UNITED STATES
DEPARTMENT OF THE INTERIOR
BUREAU OF LAND MANAGEMENTNMOCD
ArtesiaFORM APPROVED
OMB NO. 1004-0137
Expires: January 31, 2018**SUNDRY NOTICES AND REPORTS ON WELLS**
Do not use this form for proposals to drill or to re-enter an abandoned well. Use form 3160-3 (APD) for such proposals.

XTO Permian Operating, LLC requests permission change the formation from Cotton Draw Bone Spring South (Oil) to Purple Sage Wolfcamp (Gas).

XTO Energy Inc.
PLU 15 Twin Wells Ranch #905H
Projected TD: 22462' MD / 11981' TVD
SHL: 330' FSL & 2560' FWL , Section 15, T24S, R31E
BHL: 200' FSL & 2310' FEL , Section 27, T24S, R31E
Eddy County, NM

PECOS DISTRICT DRILLING CONDITIONS OF APPROVAL

11-3/4" x 8-5/8" x 5-1/2" 10M RSH-2 Wellhead
Assembly, With T-EBS-F Tubing Head

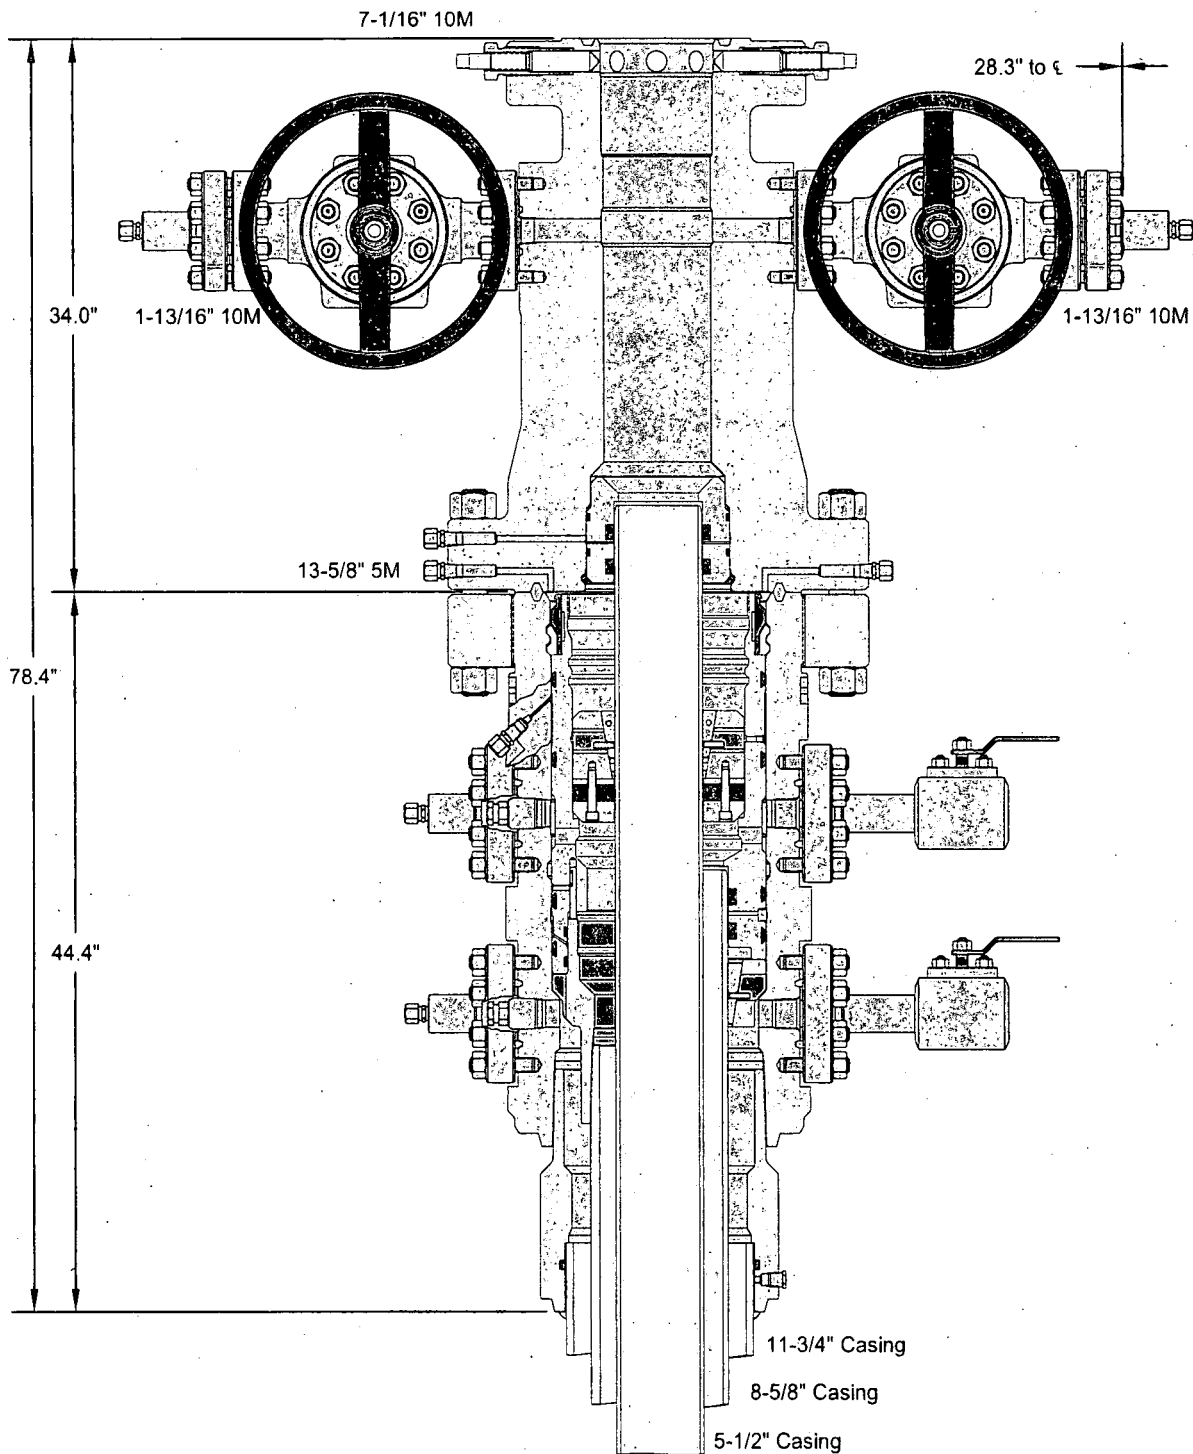
4. **Operator has proposed a multi-bowl wellhead assembly. This assembly will only be tested when installed on the 11-3/4 inch 1st intermediate casing. Minimum working pressure of the blowout preventer (BOP) and related equipment (BOPE) required for drilling below the 11-3/4 inch 1st intermediate casing shoe shall be 5000 (5M) psi.**

- a. Wellhead shall be installed by manufacturer's representatives, submit documentation with subsequent sundry.
 - b. If the welding is performed by a third party, the manufacturer's representative shall monitor the temperature to verify that it does not exceed the maximum temperature of the seal.

- c. Manufacturer representative shall install the test plug for the initial BOP test.
 - d. Operator shall perform the 8-5/8 inch 2nd intermediate casing integrity test to 70% of the casing burst. This will test the multi-bowl seals.

- e. If the cement does not circulate and one inch operations would have been possible with a standard wellhead, the well head shall be cut off, cementing operations performed and another wellhead installed.

2M & 3M Choke Manifold Diagram
XTO

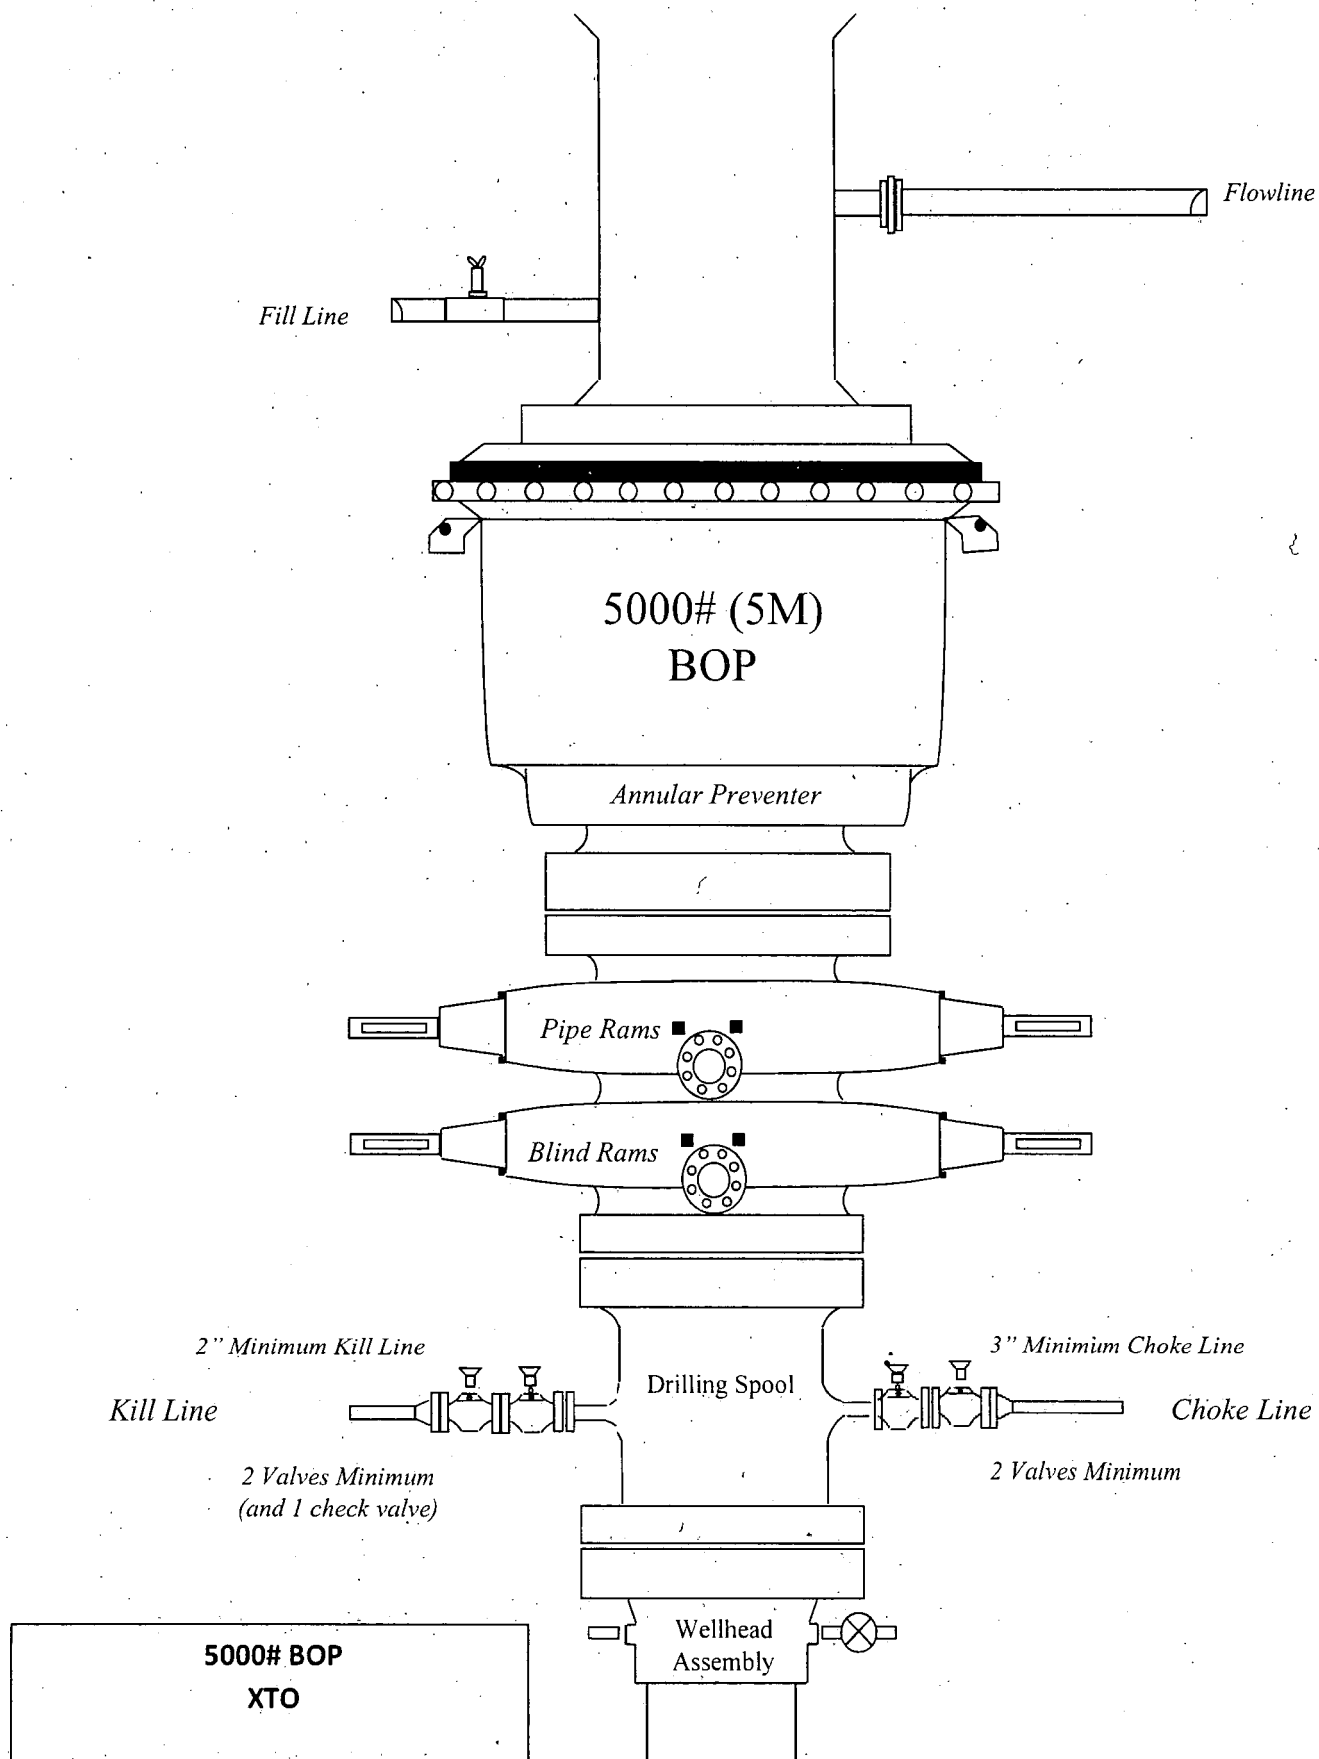
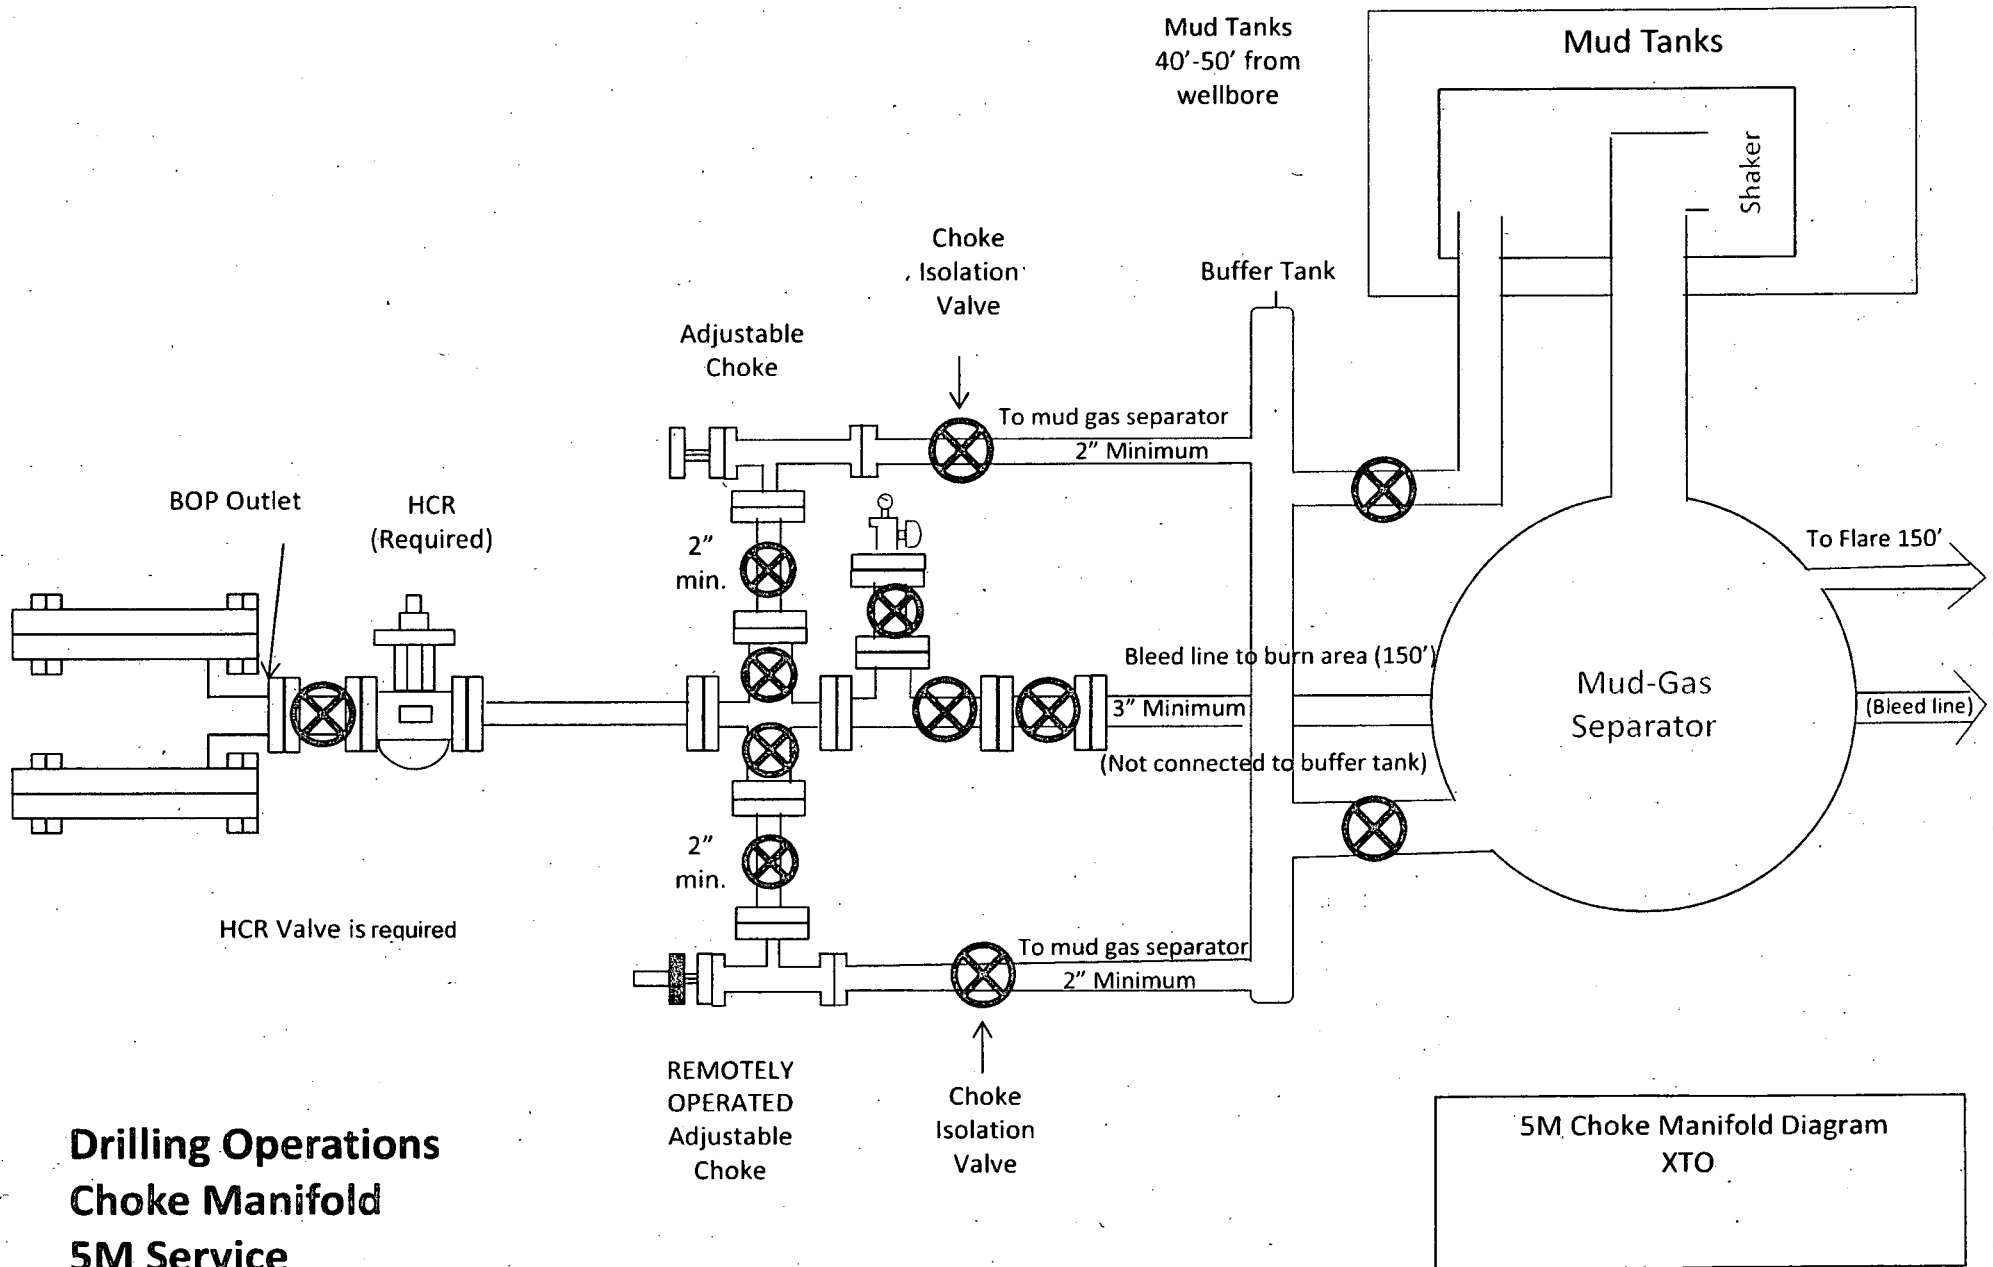
2. Variance approved to use flex line from BOP to choke manifold. Check condition of flexible line from BOP to choke manifold, replace if exterior is damaged or if line fails test. Line to be as straight as possible with no hard bends and is to be anchored according to Manufacturer's requirements. The flexible hose can be exchanged with a hose of equal size and equal or greater pressure rating. **Anchor requirements, specification sheet and hydrostatic pressure test certification matching the hose in service, to be onsite for review. These documents shall be posted in the company man's trailer and on the rig floor.** If the BLM inspector questions the straightness of the hose, a BLM engineer will be contacted and will review in the field or via picture supplied by inspector to determine if changes are required (operator shall expect delays if this occurs).
